1 This document contains suggested text to resolve comments regarding P802-REVc-d1.0.

**Figure 1—An example of a bridged IEEE 802 network**

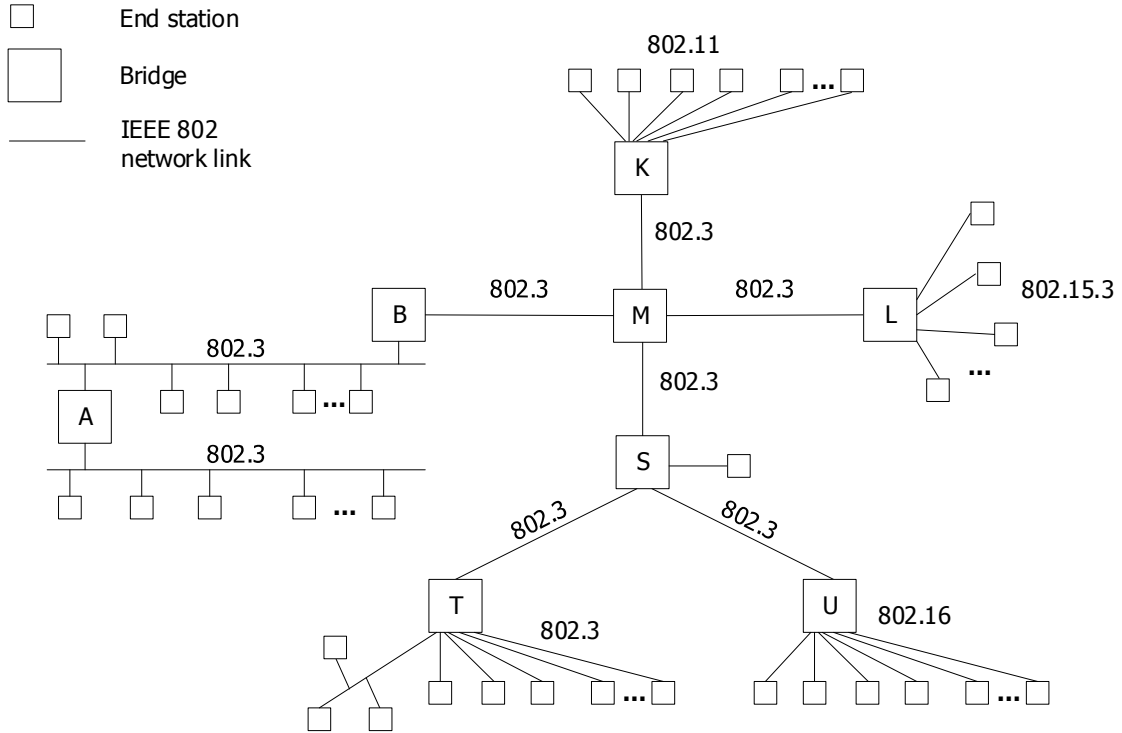
13 *Subclause 5.2.3.6 is now 5.2.3.8 with the changes shown to address CID 4, CID 37, CID 59, and CID 94*

21 Figure 1 illustrates an example of a bridged IEEE 802 network that can be configured with bridge-style  
22 interconnection. The bridges A and B, and the IEEE 802.3 LAN configurations to which they attach, are  
23 typical of the older style of bridged IEEE 802 network in which a bridge interconnects a small number of  
24 access domains, each containing many end stations, as is similar with K and L and ~~M~~ ~~their IEEE 802.17™~~  
25 ~~ring. The IEEE 802.17 ring~~ and the IEEE 802.3 connections ~~to M and those~~ between S and T and S and U  
26 form backbone networks. On the other hand, the bridges S, T, and U function as bridges that combines ~~IEEE~~  
27 ~~802.17, IEEE 802.3, and IEEE 802.16™~~ networks. ~~S and M are is~~ backbone bridges, handling a number of  
28 network attachments. T and U are bridges that support multiple end stations, with connection to a backbone  
29 network. B and K also provide access to a backbone network. The end station shown connected to S by a
